Access Compliance Report

Public Rights-of-Way

(Curb Ramps)

Intersection ID: 46344	Main Street: BENNETT_NEELY_LN	Cross Street: STREAM_BANK_DR	Location: NE
ADA ID: 0E8DB08D472B	Ramp Type: PerpDiag	Initial Pass/Fail: Fail	Overall Compliance: No
Severity Score: 21.25			
Codes/Mitigation Info/Possible Solution		Field Measurements/Component Compliance

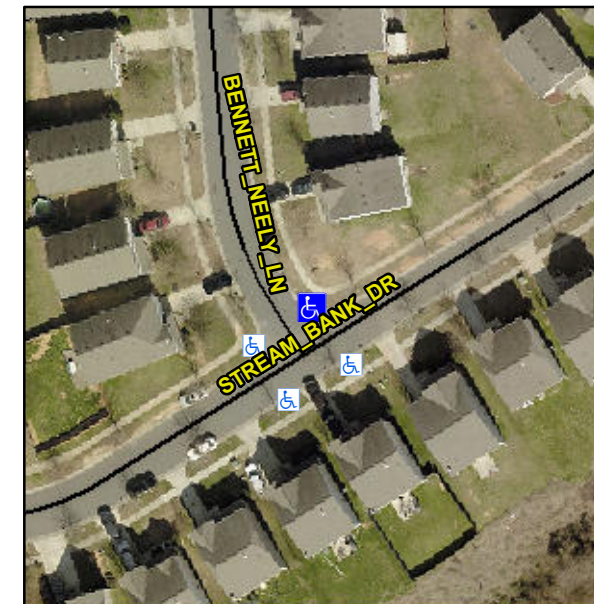
Not Found, R304.5.1, R304.5.3

Compliance	Description	Data	Compliance	Description	Data
N/A	Ramp Length (in)	86.0	Yes	Ramp Slope (%)	6.4
No	Ramp Width (in)	47.0	No	Ramp XSlope (%)	6.0
N/A	Flare Type LT	N/A	N/A	Flare Type RT	N/A
N/A	Flare Slope LT (%)	N/A	N/A	Flare Slope RT (%)	N/A
N/A	Flare Traversable LT?	N/A	N/A	Flare Traversable RT?	N/A
N/A	Landing Length (in)	N/A	N/A	DWS Provided?	N/A
N/A	Landing Width (in)	N/A	N/A	DWS Contrast?	N/A
N/A	Landing Slope (%)	N/A	N/A	DWS Length (in)	N/A
N/A	Landing X Slope (%)	N/A	N/A	DWS Full Width?	N/A
N/A	Landing Curb? (Y/N)	N/A	N/A	DWS Offset (in)	N/A
N/A	Shared Landing?	N/A			
N/A	Gutter Ponding?	N/A	N/A	Gutter Slope (%)	N/A
N/A	Gutter Lip Ht (in)	N/A	N/A	Gutter X Slope (%)	N/A
N/A	Painted X Walk1?	No	N/A	Painted X Walk2?	No
	X Walk 1 Direction	To SW		X Walk 2 Direction	To SE
N/A	X Walk 1 Width (in)	N/A	N/A	X Walk 2 Width (in)	N/A
	X Walk 1 Slope (%)	4.9		X Walk 2 Slope (%)	1.7
	X Walk 1 X Slope (%)	3.1		X Walk 2 X Slope (%)	4.4

Remove & Replace Curb Ramp With Two New Directional Ramps or Equivalent.
